Staff Report Memorandum September 7, 2023

To: Planning Commission
From: Community Development Department
Subject: Sandy Station Block 59 Subdivision
(Preliminary Subdivision Review)
8810 S 90 E
(Community #4, Historic Sandy)

SUB09232022-006408
R-1-7.5(HS)
.23 Acres
2 Lots

Exhibit "B"

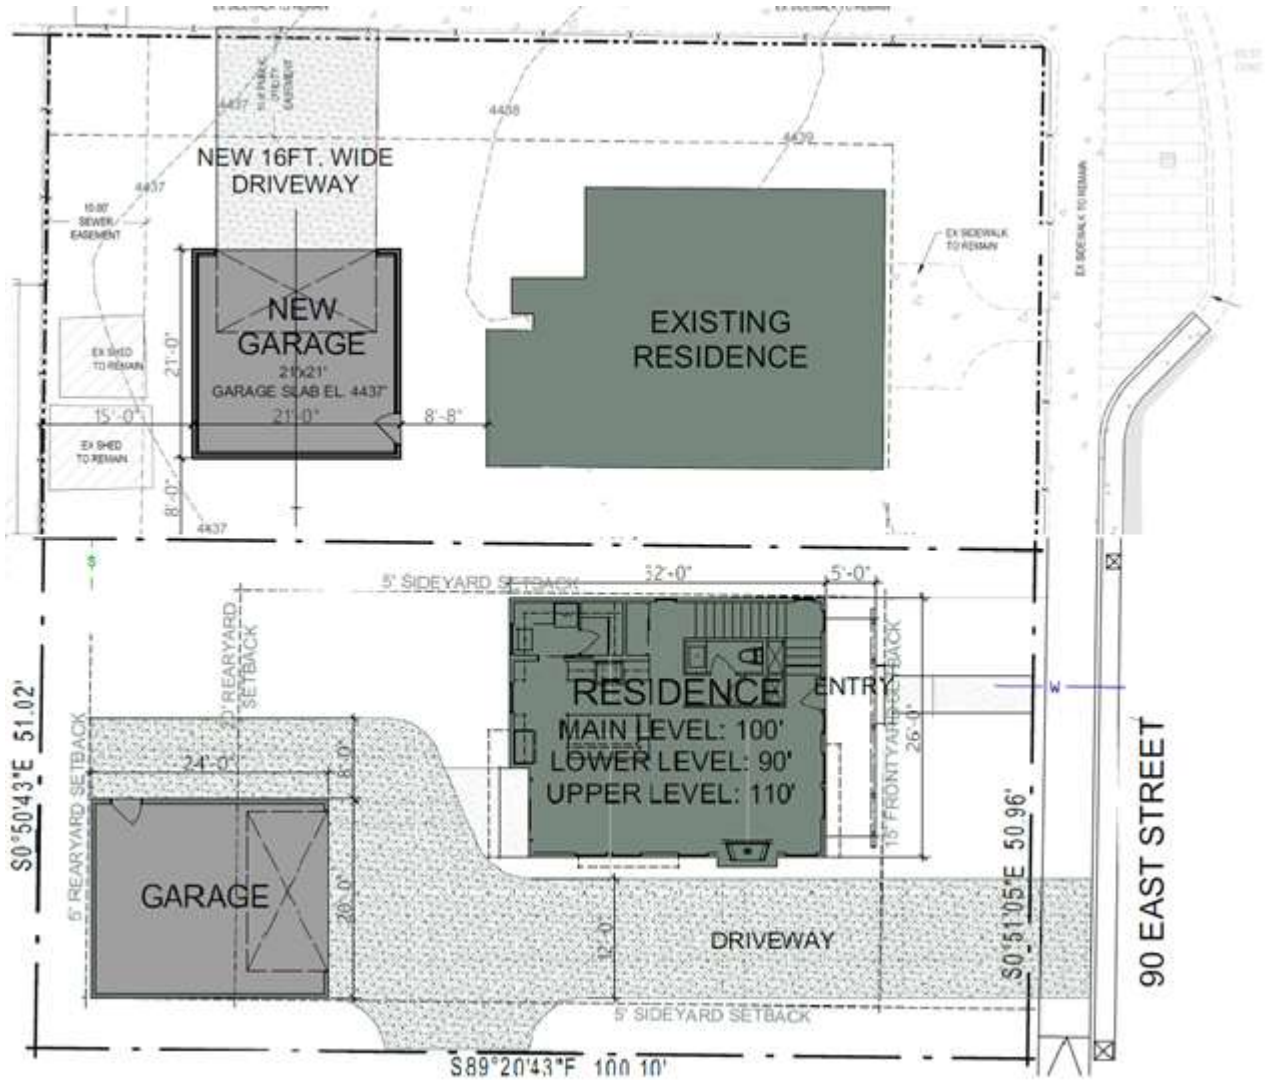
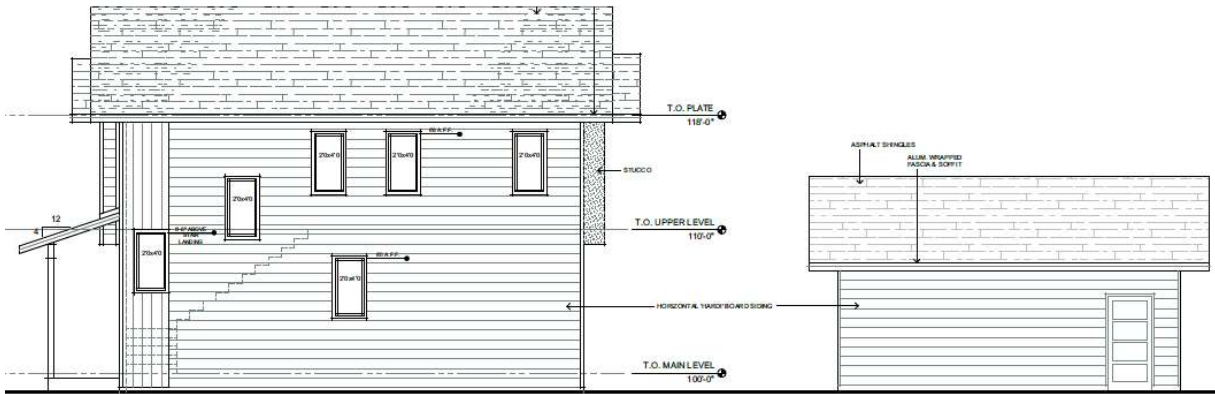
An additional requirement of the HSD Overlay Zone is that development plans must be presented before the Historic Preservation Committee for review. This review took place on August 23, 2023. The Committee recommended approval of the proposal based upon the guidelines while making the following suggestions:

- That the siding on the front elevation be run horizontally instead of running both vertically and horizontally.
- That the front gable end be adorned by either a change in material or the addition of a vent or faux window.
- That the front porch eaves be extended to cover and extend beyond the edge of the façade.

The Planning Commission must review and approve of the proposed building elevations which are found in Exhibit B.

4. That the building elevations for the new structures proposed by the applicant be approved as shown in the application materials.
5. That the existing home have a new detached garage built within six months of the recordation of the subdivision or prior to the sale of the lot to another owner to ensure that this lot remains in a legal conforming condition.
